Iowa Department of Transportation Office of Contracts

Date of Letting: January 21, 2015 Date of Addendum: January 15, 2015

B.O.	Proposal ID	Proposal Work Type	County	Project Number	Addendum
106	66-C066-049	PCC OVERLAY -	MITCHELL	STP-S-C066(049)5E-66	21JAN106.A03
		UNBONDED

SHEET C.01:

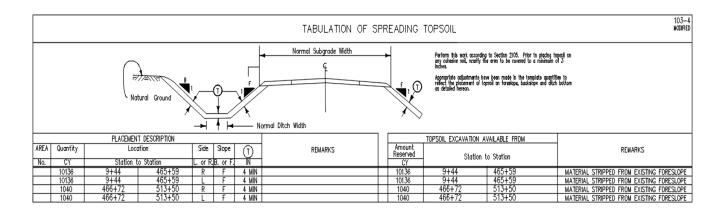
Delete the last sentence in Item Note 2 "MATERIAL SILTED IN THE"

Add the following to the ESTIMATE REFERENCE INFORMATIO NOTE FOR 2105-8425015 TOPSOIL, SALVAGE AND SPREAD

SEE ATTACHED TABULATION 103-4 FOR INFORMATION. EXISTING FORESLOPES ARE TO BE STRIPPED PRIOR TO SHOULDER WORK AND THE TOPSOIL REPLACED AFTER EARTH SHOULDER WORK IS COMPLETE
